Product Change Notification

Date Issued :	September 26, 2025	PCN Number :	517342
Reason for Change :	Change Supplier		
Description of Change :	This notification is to inform you about addition of new Supplier impacting the part(s) as per attached list. No changes will be made to product as part of this change		
Assessment of Change :	Supplier Qualification Test Report/s		
Planned Implementation Date :	May 30, 2026		
Customer Sample Availability Date:	March 15, 2026		
Last date to request Samples by Customer :	February 15, 2026		
Please note if Samples are not requested as per Customer Samples Request date, it may take additional 4-6 weeks to arrange Samples.			
Traceability Code Markings / Date :	No special marking on the product or packaging

34062 series connector

Photo of affected product

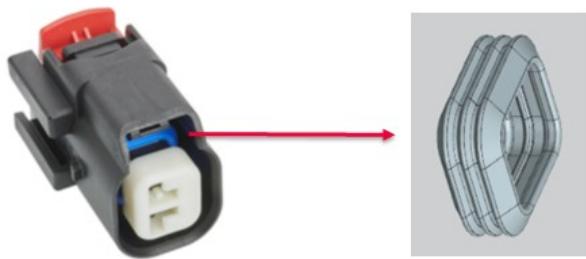
- To strengthen the MX150 materials supply chain and add optionality, we are qualifying an additional supplier for the ring seal in series 34062
- The supplier is already a current supplier to Molex Chengdu
- This change will have no impact to fit, form or function of the part
- There will be no change to finished goods part numbers
- Part Number Impact
 - See attached impacted parts list
- Qualification Reports and samples available upon request
- PCN will be implemented once all required qualification/ validation has been completed and all necessary approvals have been obtained
